TEAC

TECHNICAL INFORMATION

CD-RW700/RW-800, Phase Difference on Analog In/Out

No. **0101**
DATE 15th March 2001

AUDIO/POWER PCB Assy (Bottom Side)

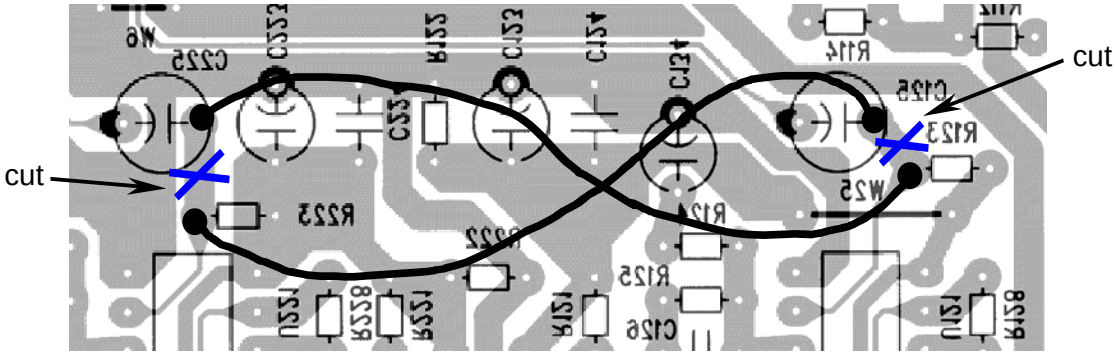
U122 (CRYSTAL CS4223, audio codec) on the Audio/Power PCB Assy has a native phase difference between L and R by one sample.

To correct the phase difference, change in the following pages has been made on the products with S/No. 0080001 and higher.

①
- Cut foil pattern at two spots.
- Add 2 pcs of jumper wires.

②
- Remove R150 and R250 (680 Ω).
- Mount 2 pcs of 680 Ω resistor as shown below.

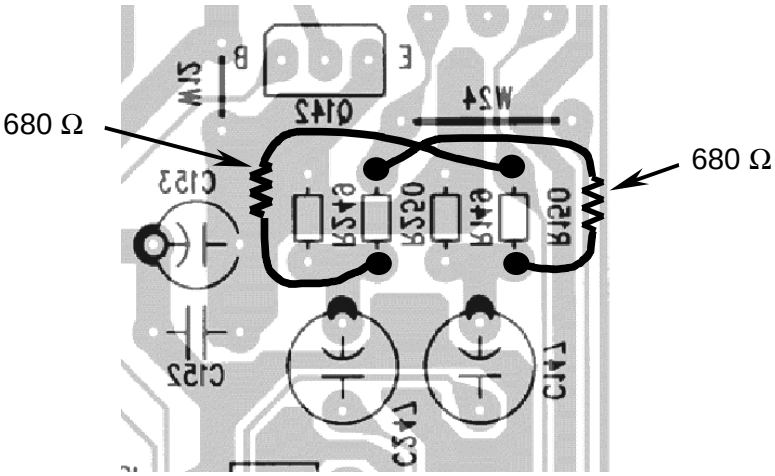
Note: Original R150/R250 are 680 Ω. Then they can be re-used but lead wire may be short requiring extension with additional wires.

CONVERTER PCB Assy (Top Side)

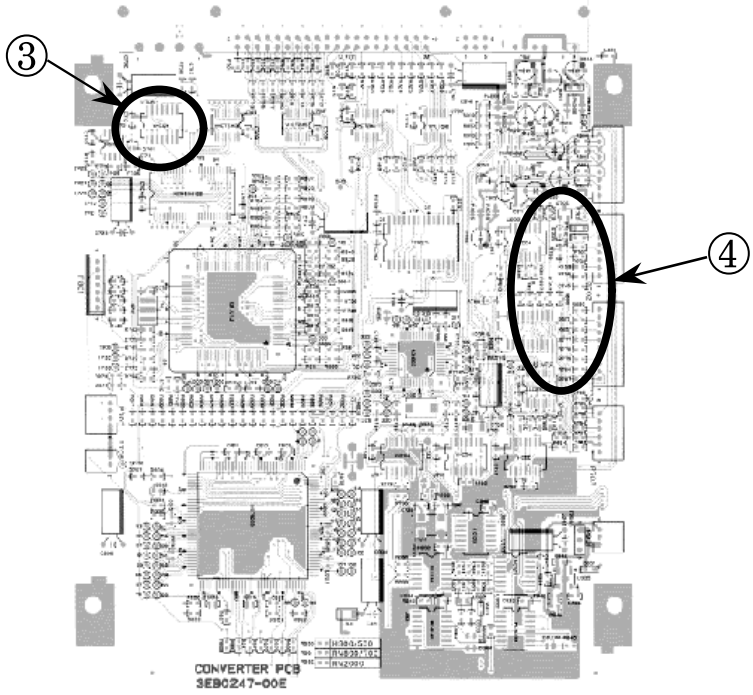
- Cut foil pattern between U706-11 and GND.
- Cut foil pattern between R780 and through hole.
- Add a jumper wire between U706-10 and R780.
- Add a jumper wire between U706-11 and R909.
